ERCOUPE
SERVICE
MEMORANDUM

No. **31**

SUBJECT: Fuel System Operation

FIG. #1

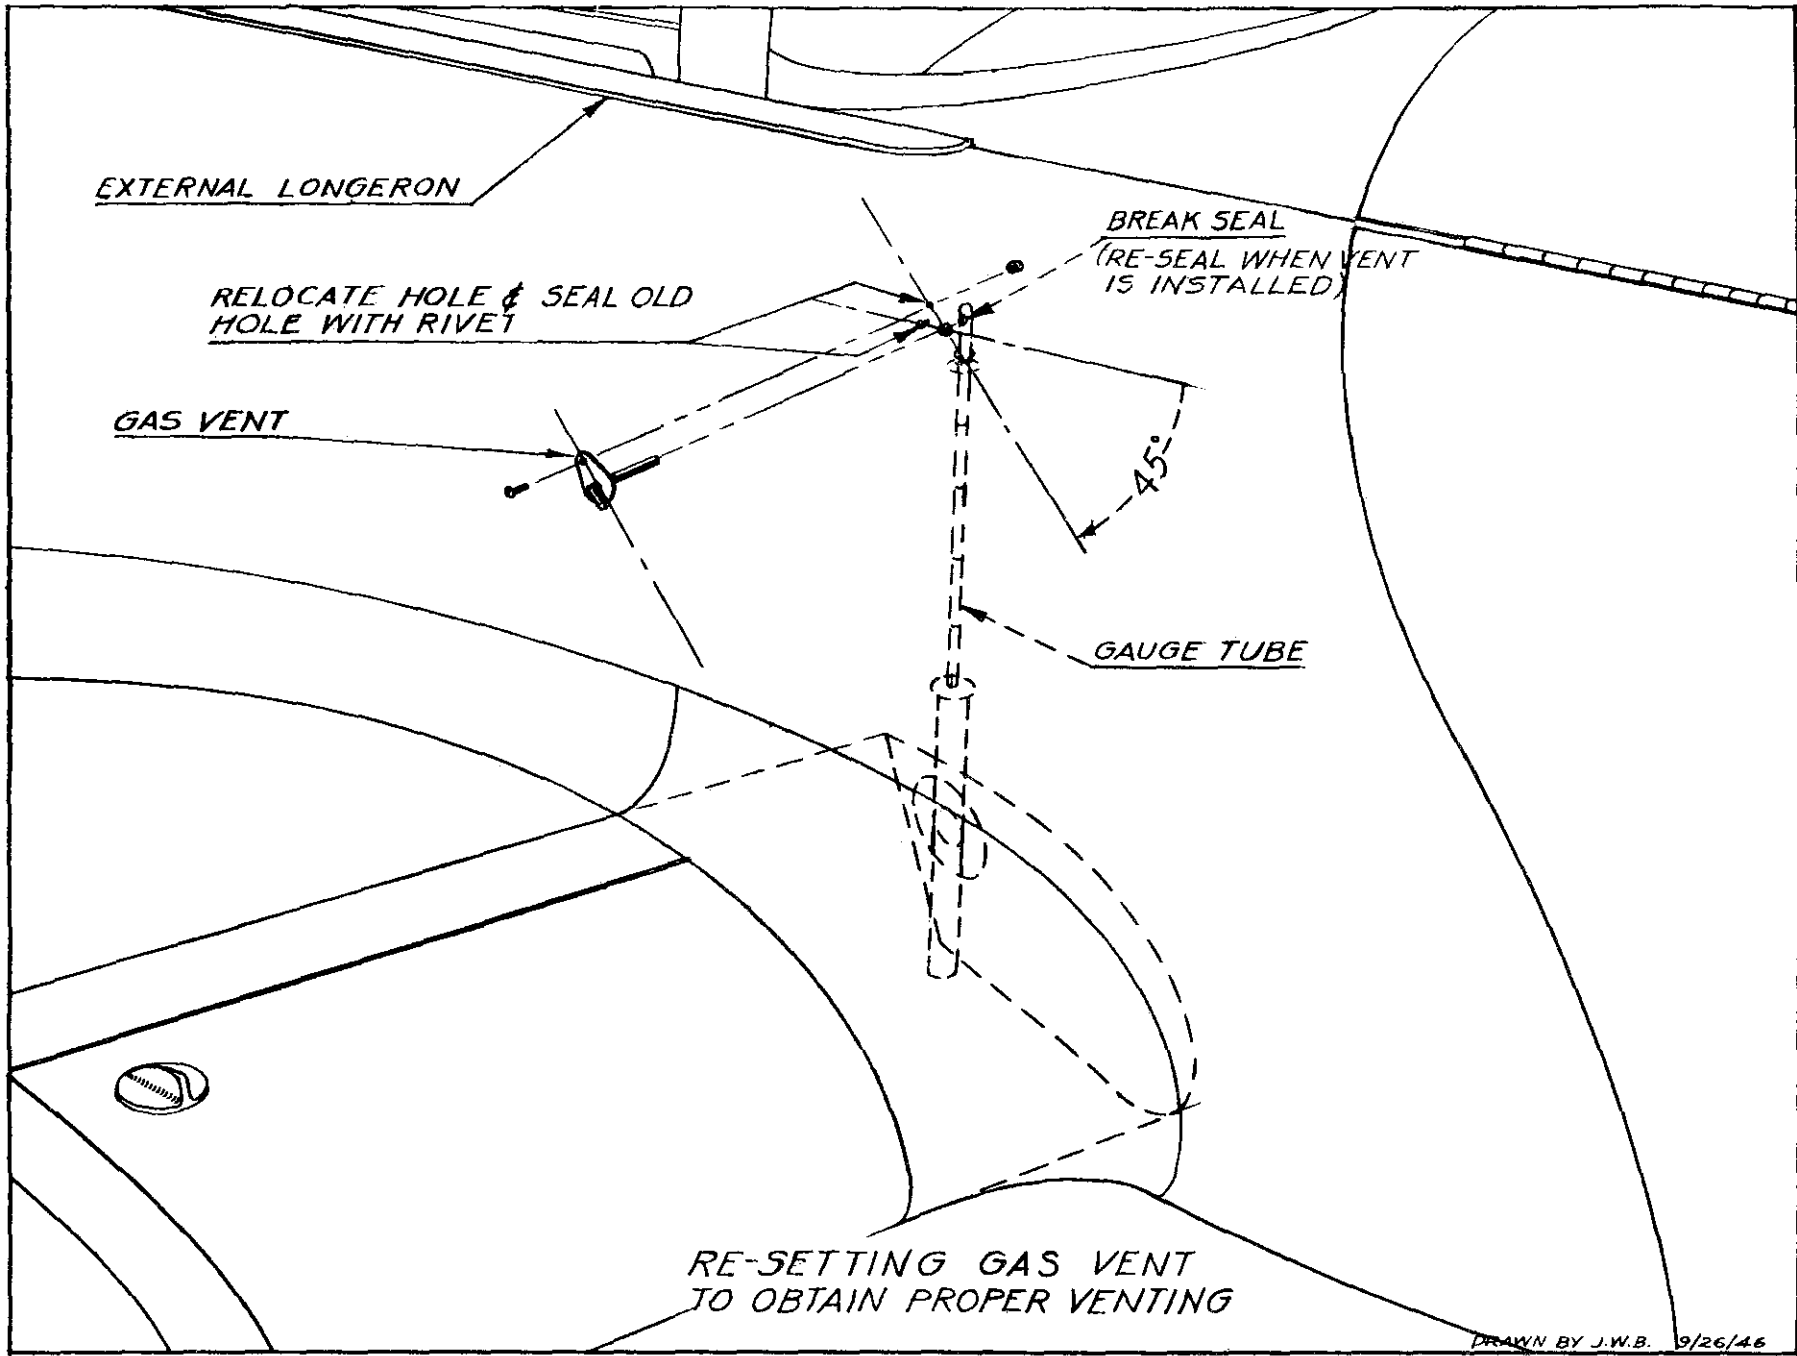
it consists of a float type indicator, encased in a plastic tube. It is marked full, half full, and empty. This gage may give false readings due to improper venting, chiefly the error is reading half full in flight when more than half full of gas. This can be remedied on Ercoupes Serial Numbers 513 to 2623, by complying with the following procedure:

Affected part—415-48089—Vent Assembly

1. Remove 6 x 32 screw and nut which attaches vent to the right side of the fuselage.
2. Break the vent loose from the gage tube by turning the vent.
3. Realign the vent, by lowering the forward end, until it lies in a position from 40° to 45° with relation to the external longeron.
4. Drill a No. 28 hole through the fuselage skin, using the vent plate as a guide.
5. Insert the same 6 x 32 screw that was removed in operation No. 1.
6. Reseal vent to plastic gage tube by using clear nitrate dope, or any suitable cellulose cement. (See illustration No. 1.)
7. Close the original hole with a rivet.

FIG. # 2

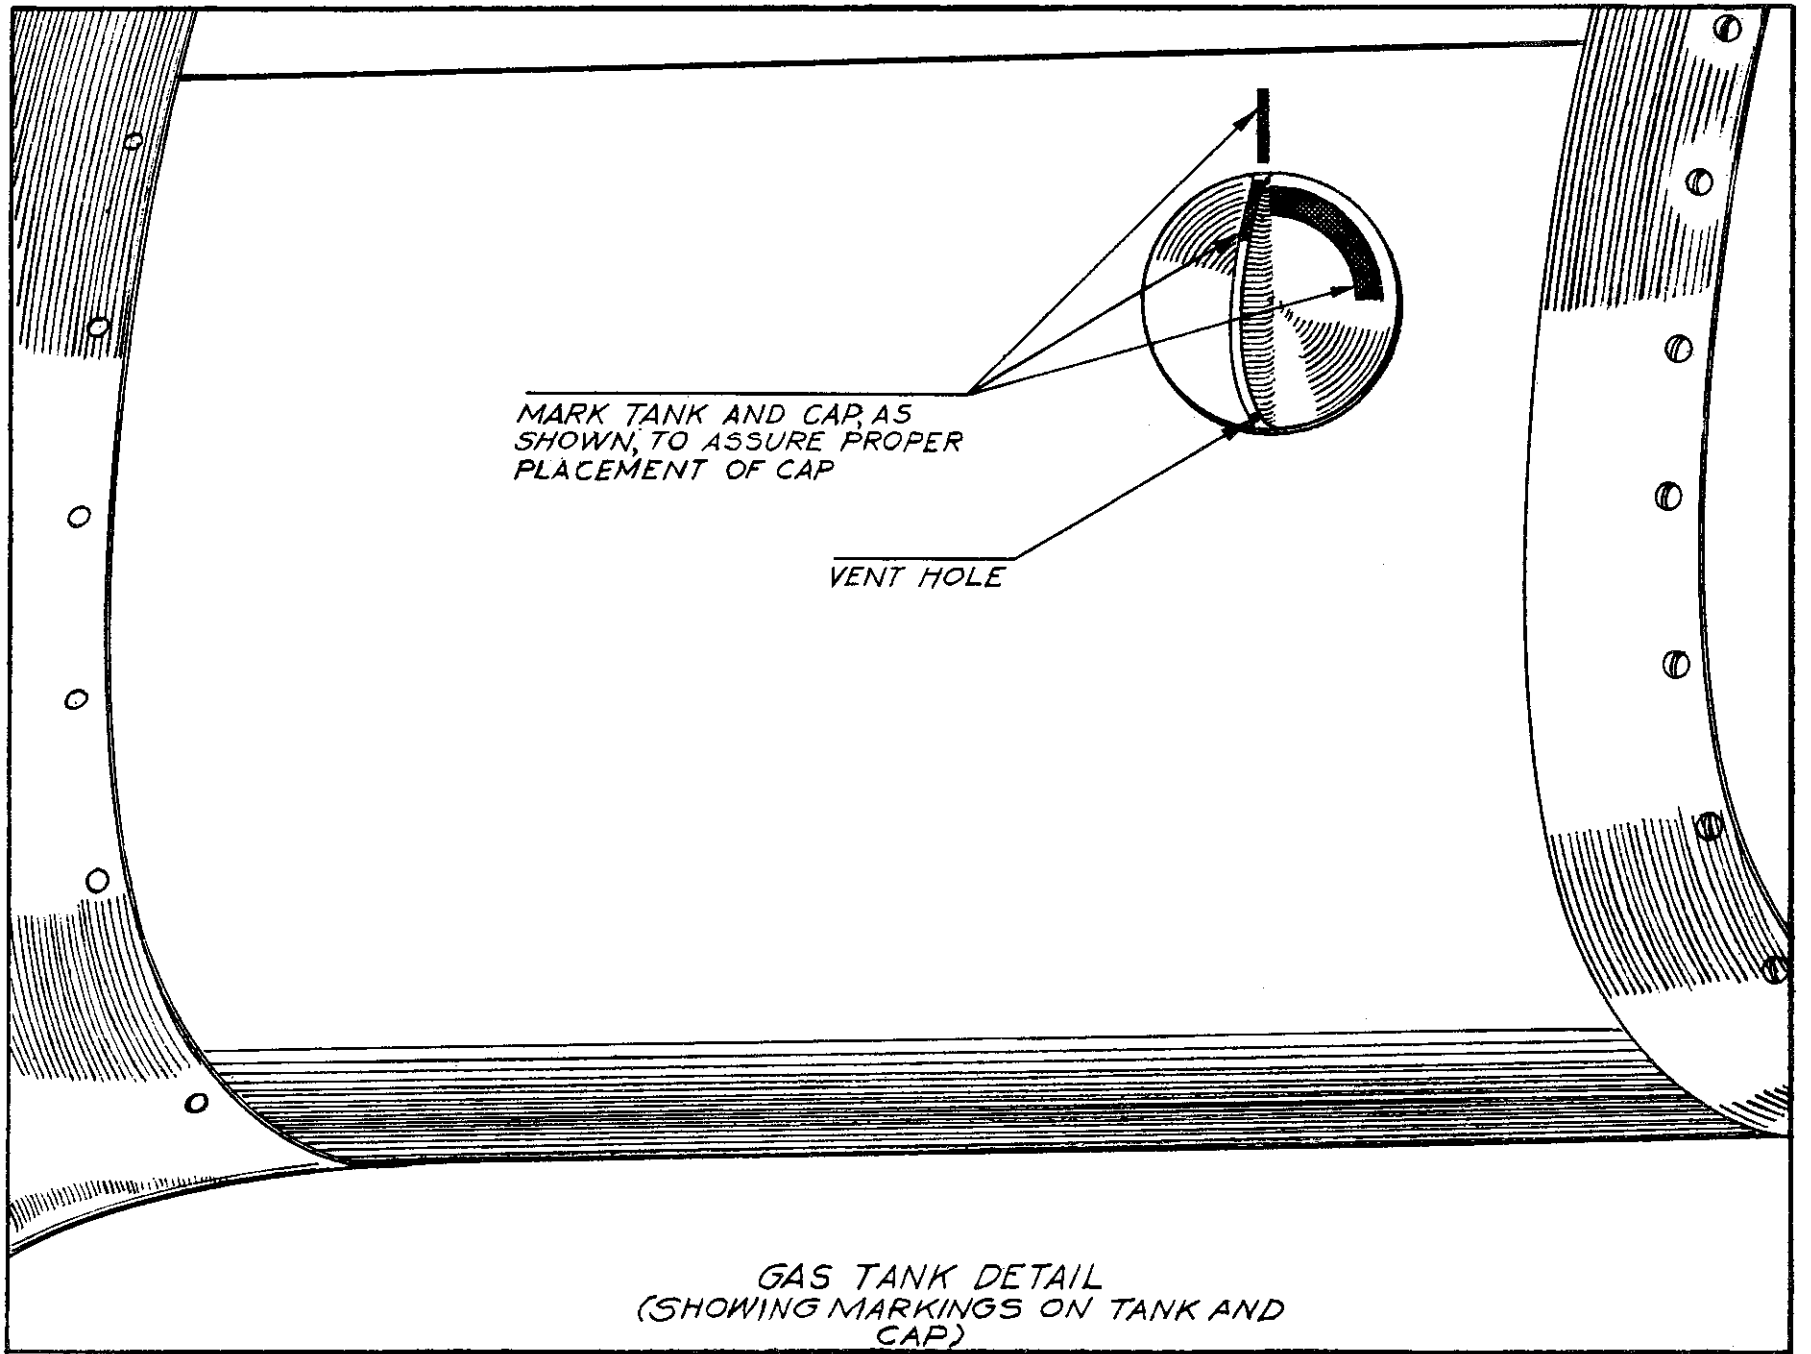
9. It has been the experience of some Ercoupe owners and operators that line mechanics put the wing tank caps on backwards. To prevent malfunctioning of the fuel system, it is imperative that the caps be put on the tanks with the vent hole to the front. This provides venting of each wing tank and will prevent syphoning or unequal flow of the fuel. Unequal flow may result in the fuel pump being unable to transfer all of the fuel from the wing tanks to the fuselage tank.

10. It is recommended that the wing tank cap be marked in a manner to indicate proper positioning. A painted red line on the wing behind the cap to match a painted sector on the cap should be used. The painted sector on the cap should extend from the point of engagement to the locked position, as indicated on accompanying sketch No. 2.

MARK TANK AND CAP, AS SHOWN, TO ASSURE PROPER PLACEMENT OF CAP
